SUBJECT: COMANCHE PEAK NUCLEAR POWER PLANT, UNITS 3 AND 4
DOCKET NUMBERS 52-034 AND 52-035
RESPONSE TO REQUEST FOR ADDITIONAL INFORMATION (RAI) NO. 4206 AND
SUPPLEMENTAL INFORMATION FOR RAI NO. 3705

Response to Request for Additional Information No. 4206 (CP RAI #135)

Supplemental Response to Request for Additional Information No. 3705 (CP RAI #97)

Figure 9.1 US-APWR Project Specific EQ Program Milestone Schedule

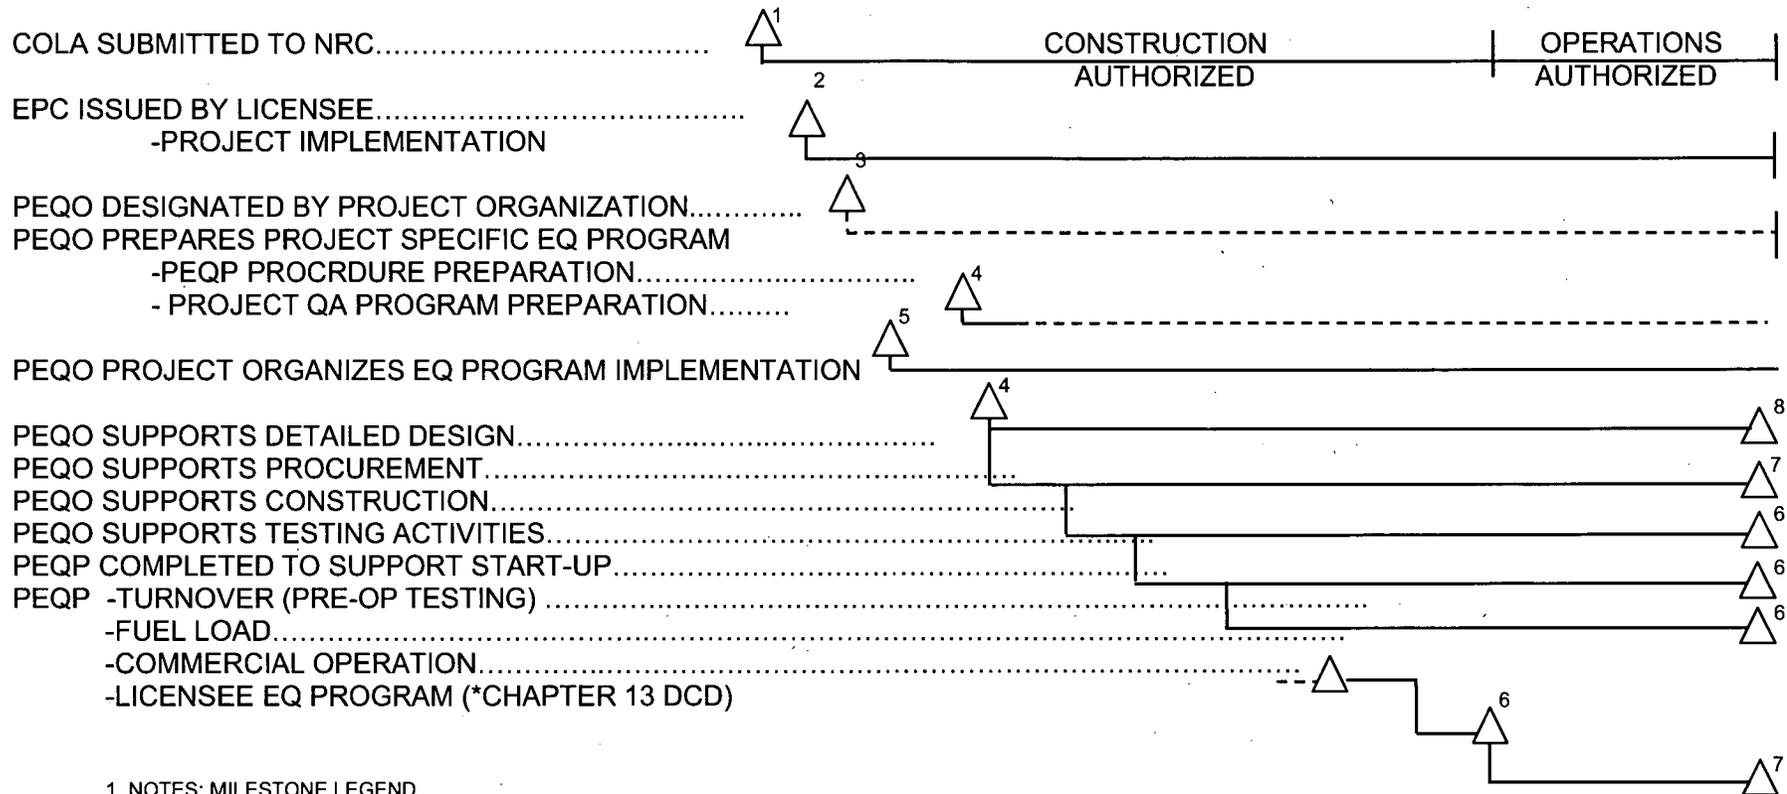
Section 3.11(3) of the US-APWR DCD states that the COL applicant is required to provide a schedule showing the EQ program proposed implementation milestones. Provide that schedule for the CP COL 3.11(3) information. In addition, explain how this will work with the operational program described in Comanche Peak Nuclear Power Plant, FSAR Table 13.4-201 as item No. 3.

Refer to the supplemental information provided for the response to Question 03.11-12 above. Figure 9.1 in MUAP-08015 Rev.1 provides a project-specific EQ program milestone schedule and is attached for the reviewer's convenience.
